**MAINE DEPARTMENT OF
INLAND FISHERIES AND WILDLIFE**

ADDENDUM NO. 2

**EFFLUENT CHARACTERISTIC DESIGN AT
EMBDEN REARING STATION**

BGS PROJECT NO.: 3289

SHEET
15A-201

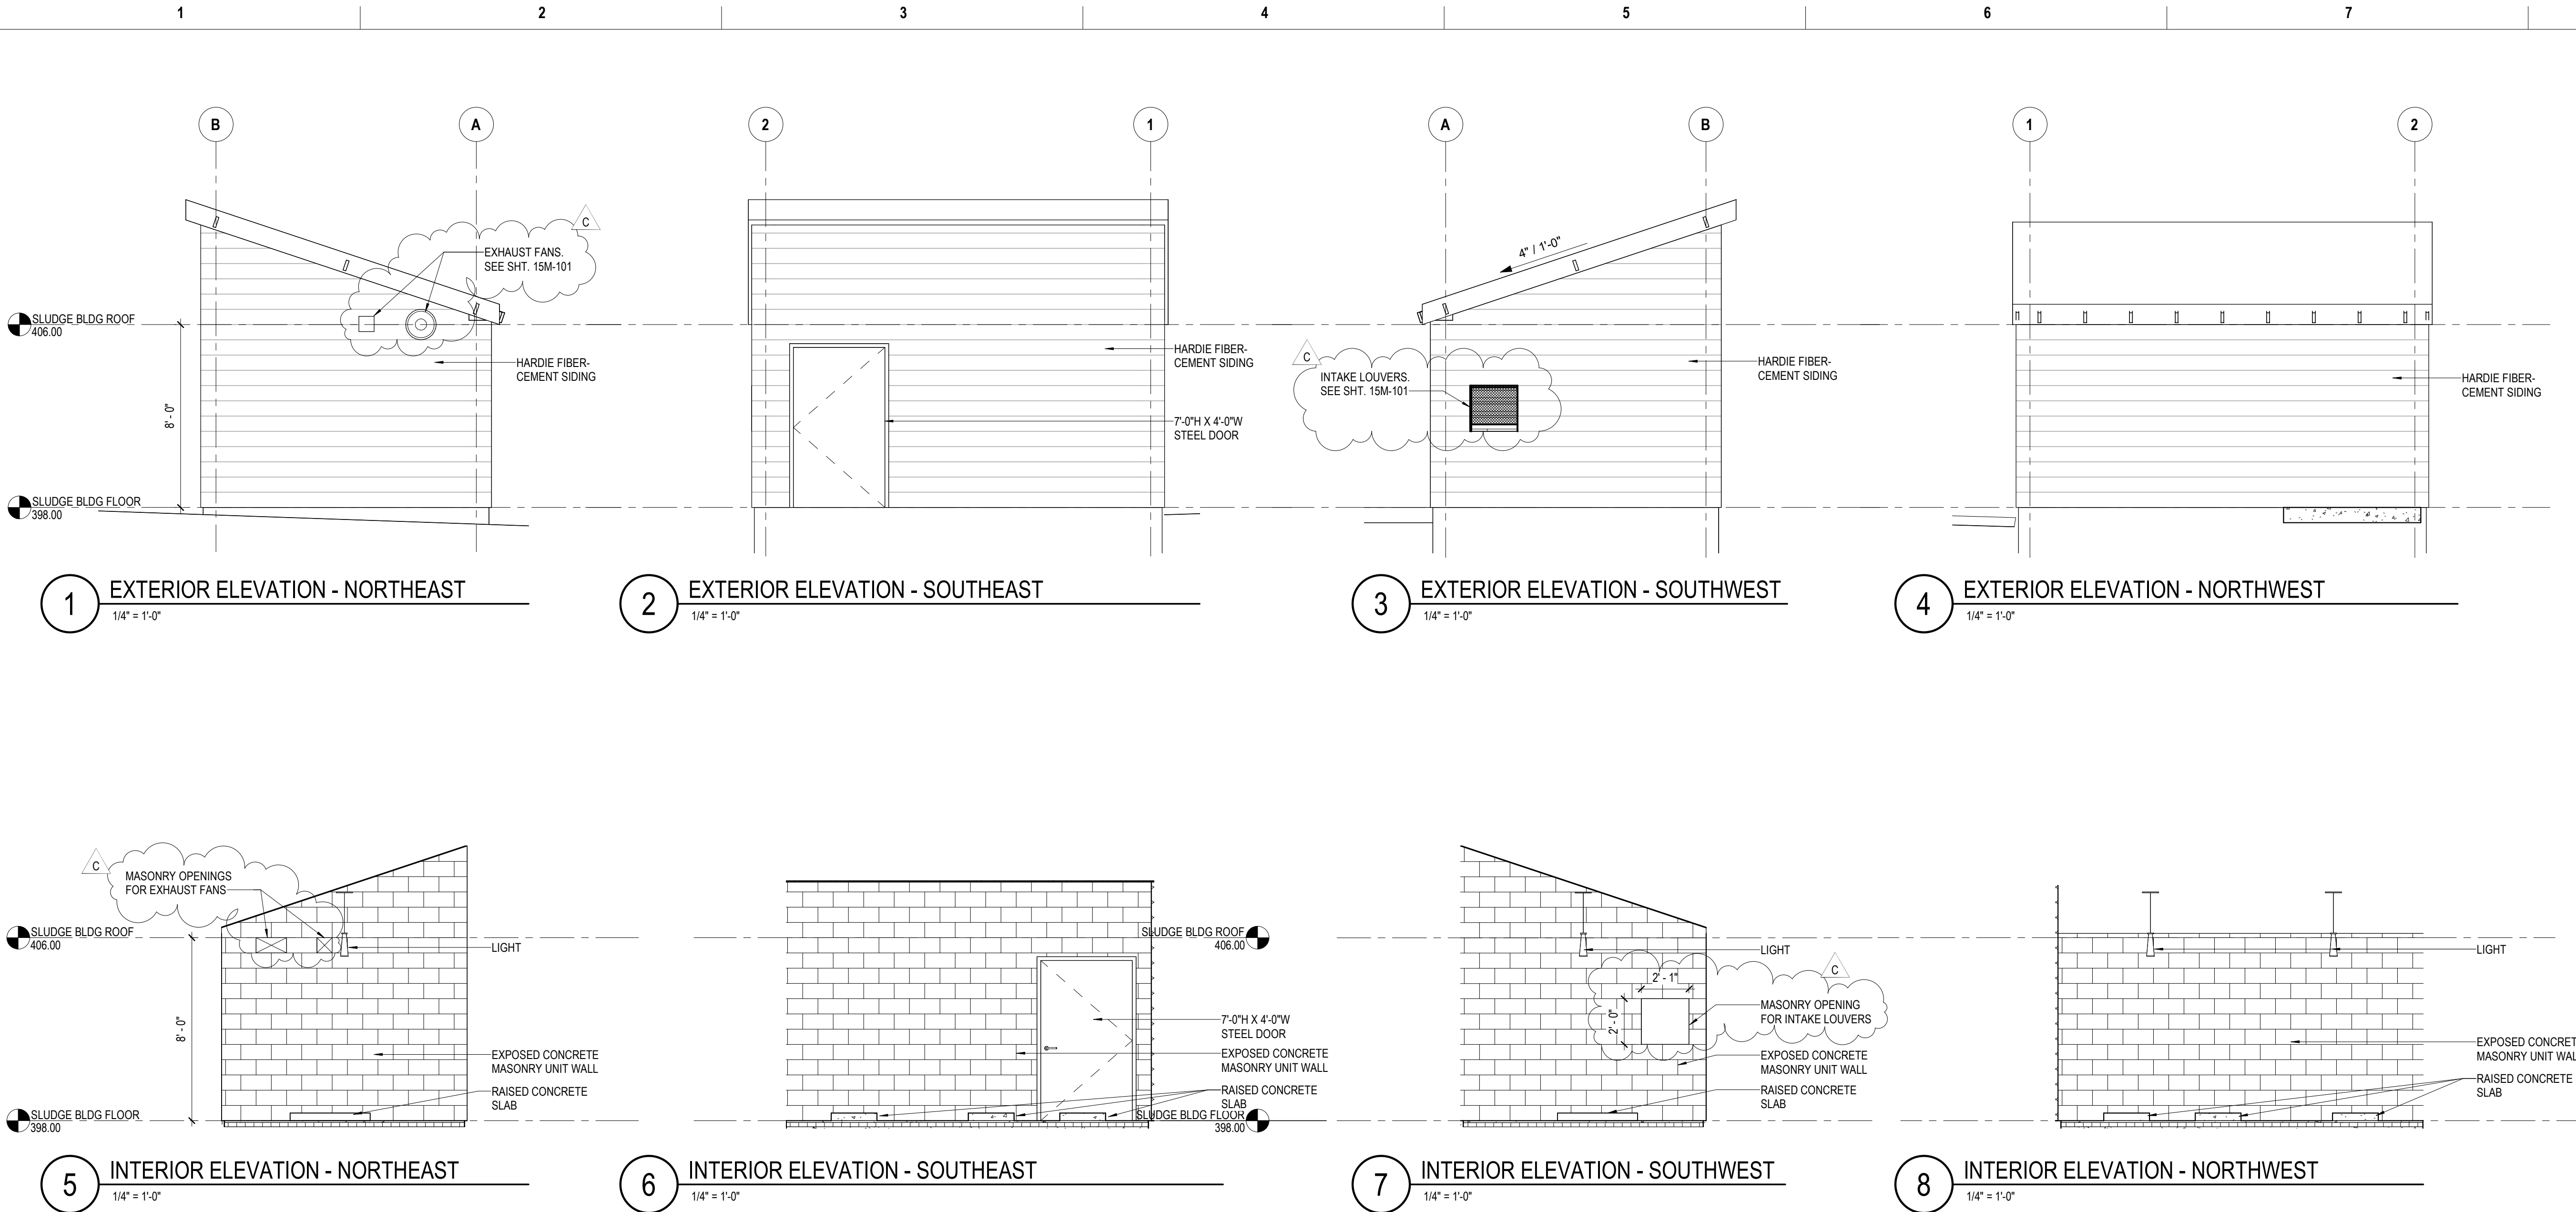
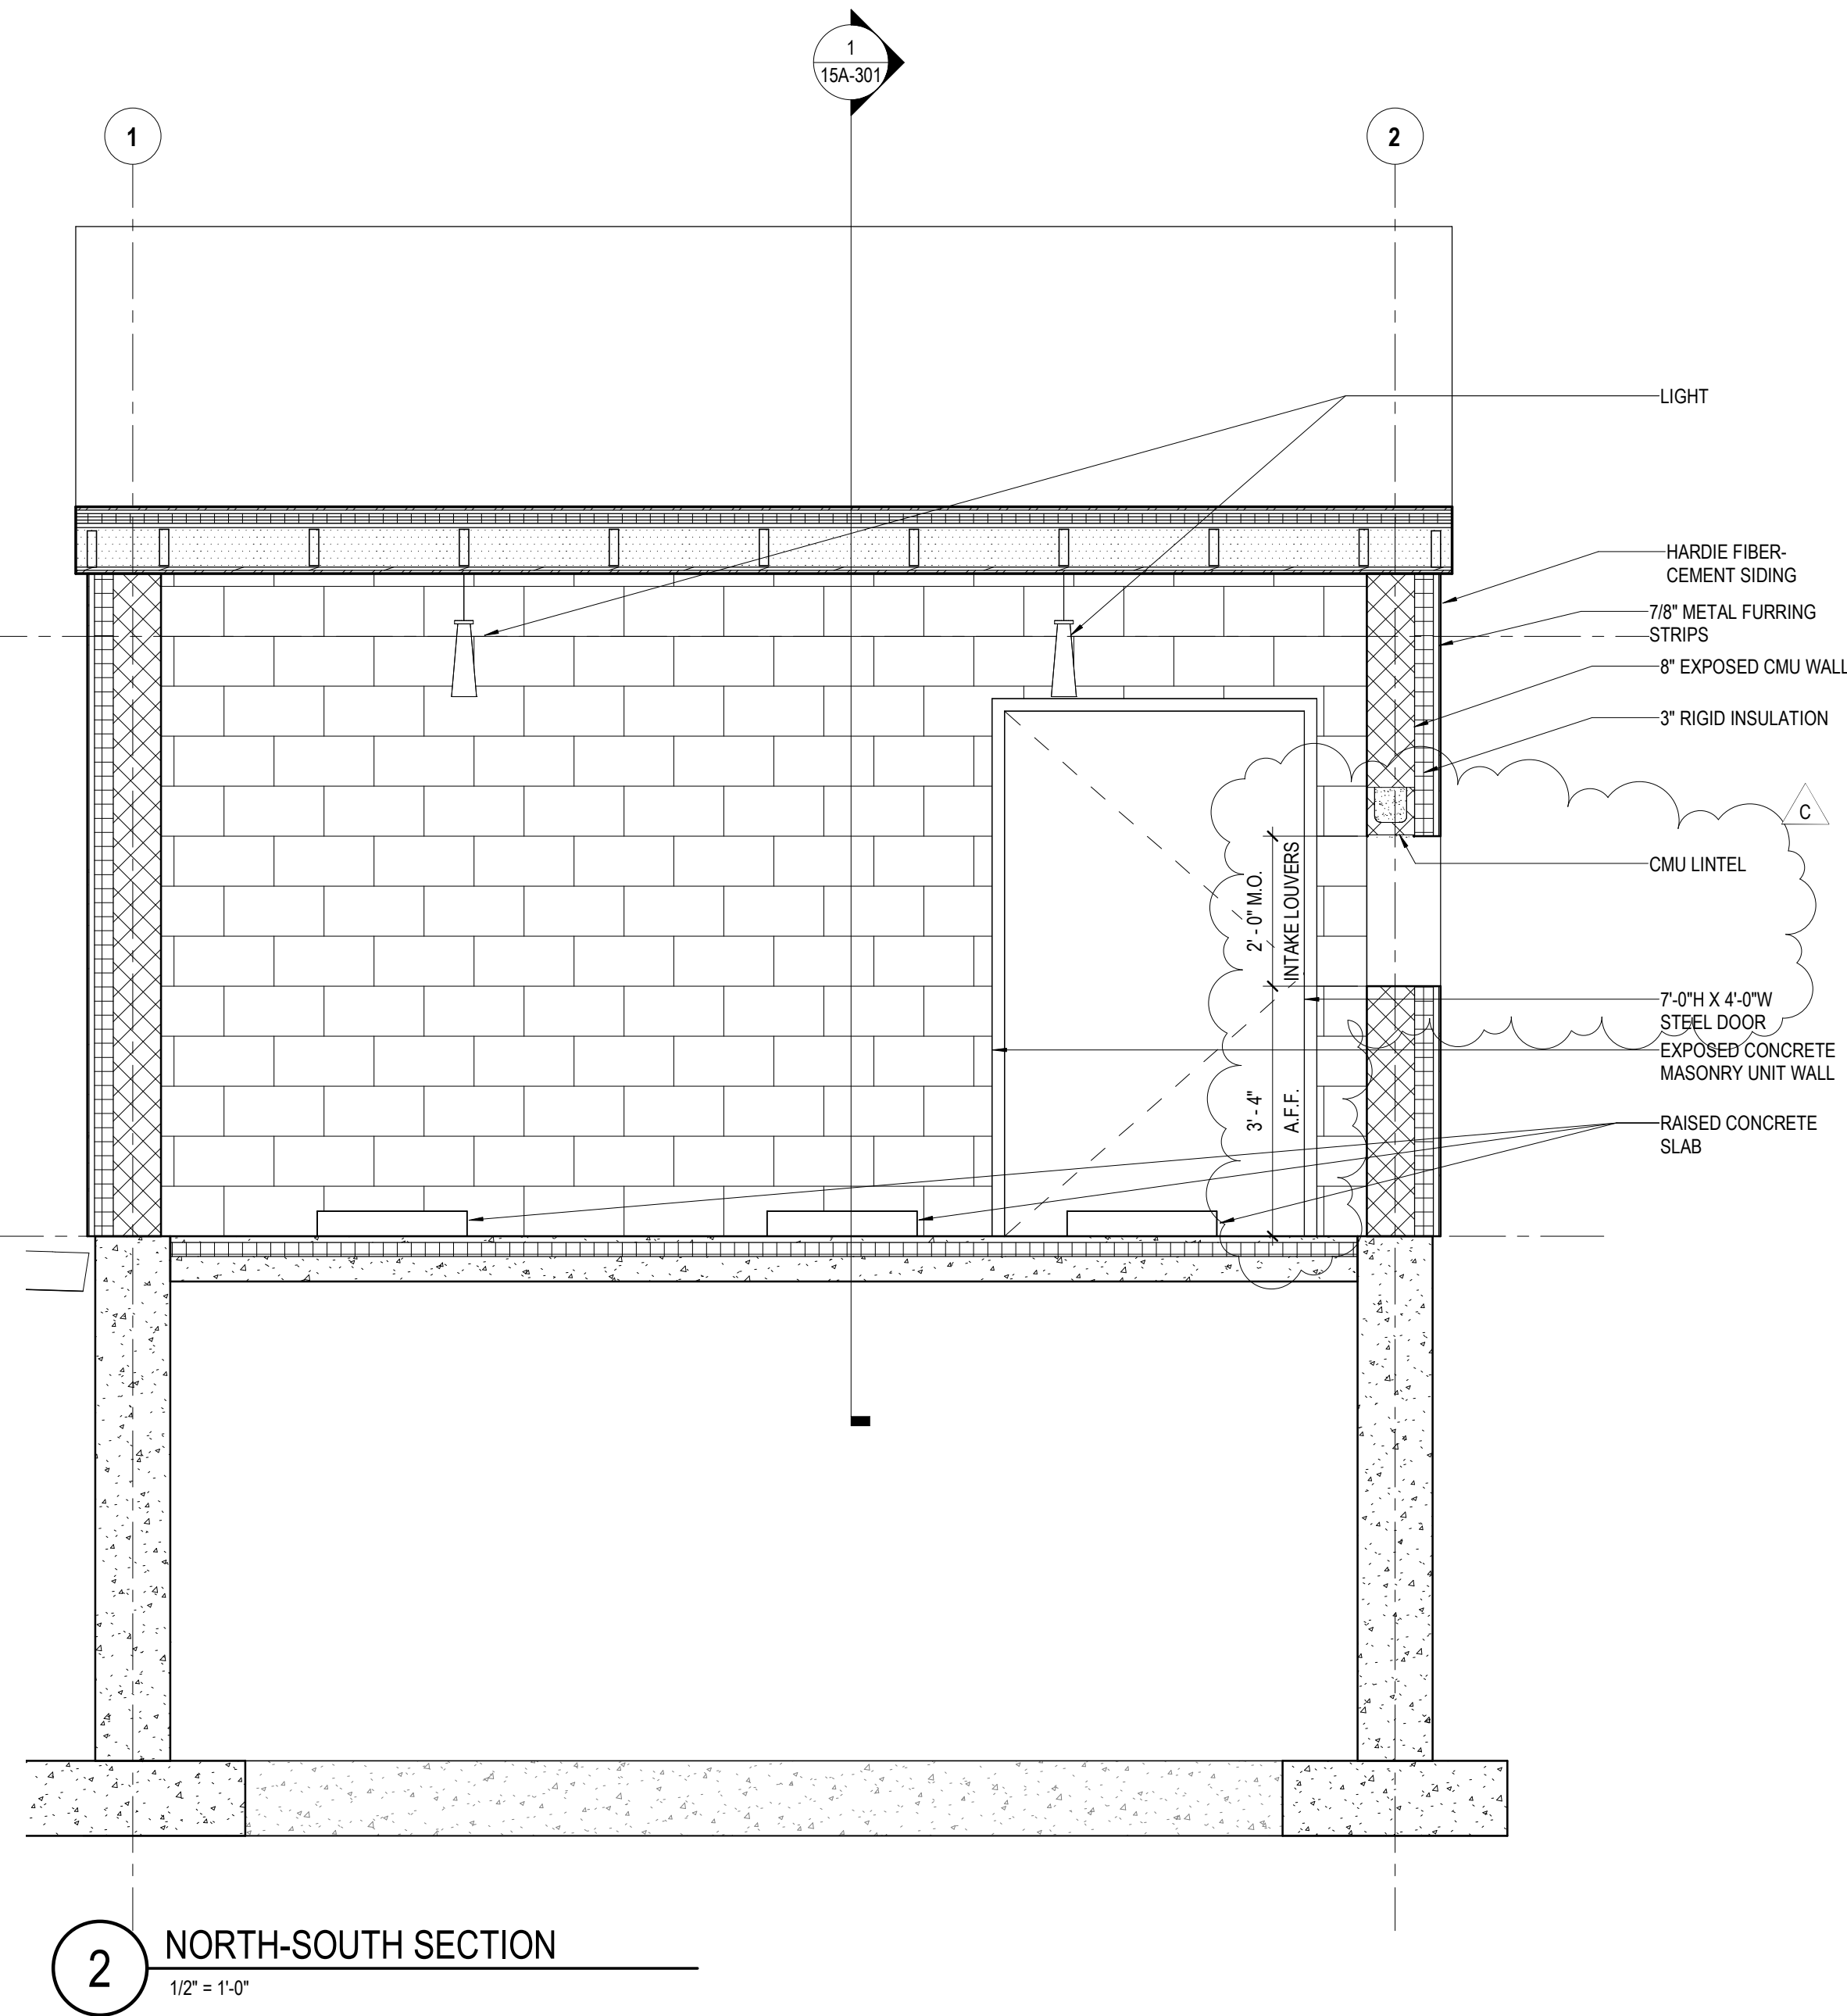
- 74. QUESTION:** 15A-201 : SLUDGE MIXING PUMP BUILDING ELEVATIONS: Interior Elevations: The outside context (boundary) lines are missing for the elevations

ANSWER: The limits of the CMU hatch is the limit of the interior elevation.
